Subject: **Temple Shalom of Milton Redevelopment**  
**Traffic Impact Assessment Peer Review**

As requested by the Town of Milton, Howard/Stein-Hudson Associates (HSH) has reviewed the *Traffic Impact Assessment* (TIA) and associated site plan for the proposed Temple Shalom Redevelopment project located at 180 Blue Hill Avenue in Milton. The Traffic Impact Assessment was submitted by Vanasse & Associates, Inc. (VAI), on December 17, 2009.

The conceptual site plan is shown below.

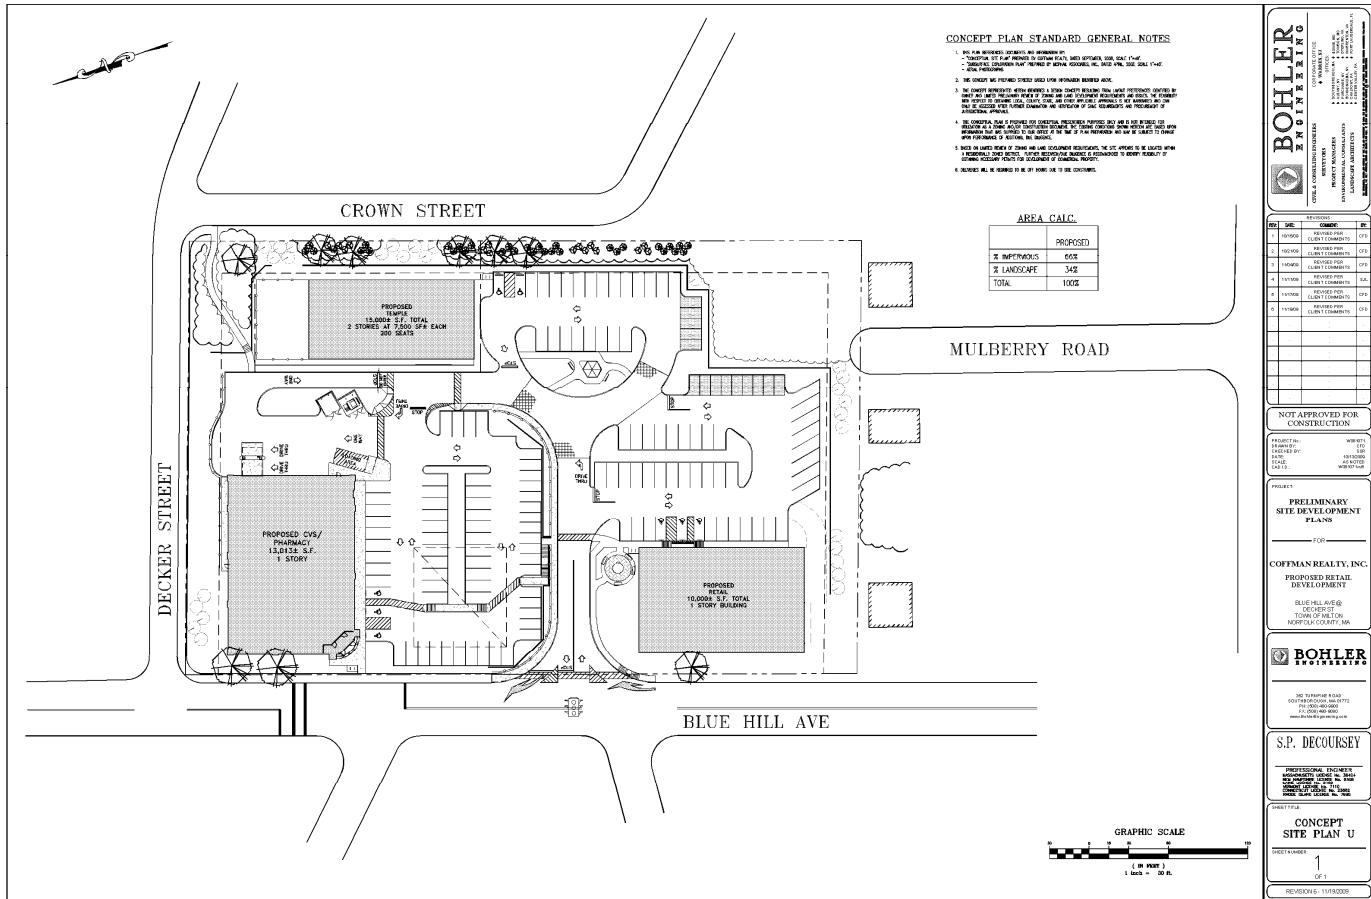
*The TIA indicates that 141 parking spaces will be provided, while 144 parking spaces are shown on the site plan. The proponent should reconcile this difference.*

*The proponent should indicate graphically on the site plan how the peak parking demand for the overall site will be accommodated.*

*Given the small number of parking spaces adjacent to the temple, the proponent should indicate graphically on the site plan how the peak parking demand will be accommodated.*

*Of the perpendicular parking spaces, 31 feature a depth of 16 feet. Review of the Town of Milton's Zoning Bylaws indicates that these spaces are likely intended for use by compact cars only. The site plan should indicate which parking spaces are designated for compact cars only. The compact car spaces should be appropriately designated.*

*The site plan should include all typical dimensions for parking stalls and circulation aisles.*

*The proposed circulation plan is unclear at the intersection of 3 internal circulation roadways in the eastern portion of the site. The proponent should clarify the proposed circulation plan at this location.*

*The proposed intersection of 3 internal circulation roadways in the eastern portion of the site should feature additional pavement markings and/or signage to better communicate the intended circulation pattern to drivers.*

*The parking lot adjacent to the Temple features a 1-way exit on the north side of the lot. This exit should feature additional pavement marking and signage that make it clear to drivers on the internal circulation roadway that the exit is one-way.*
